Teletype Corporation
Chicago, Illinois, U.S.A.

Correction Sheet 696EE
Issue 2
March, 1952

ADDITION TO PARTS BULLETINS
LISTED BELOW

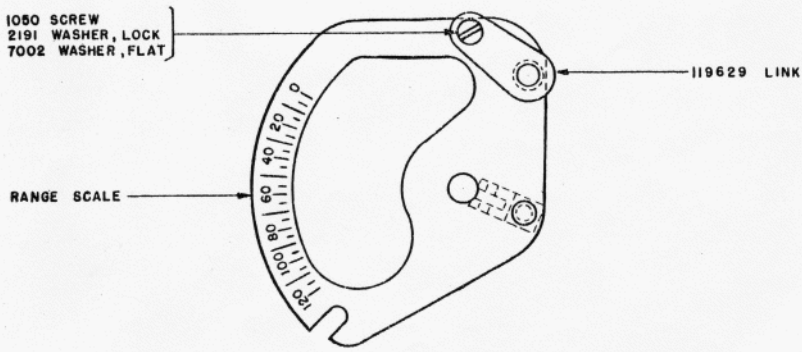
This correction sheet covers parts ordering information for the Adjustable Range Scale assembly. This assembly includes an adjusting link that mounts on the 90775 modified range scale to allow regulation of the engagement between the stop arm on the selection cam sleeve and the stop lever on the range scale assembly.

In the bulletins listed above, and in connection with each range scale assembly shown (71696, 83562, 86154, 90086, 90775, or 90776 depending on the unit), add the following parts:

119629	Link
1050	Screw
2191	Lock Washer
7002	Washer

The part numbers of the other equipment in the assembly are unchanged. The Adjustable Range Scale Assembly replaces the previous Range Scale Assembly, and orders for the old part numbers will be filled accordingly.

The two assemblies are interchangeable on the printer. Due to the modifications in the range scale, however, it is necessary to order a complete assembly to convert existing apparatus.
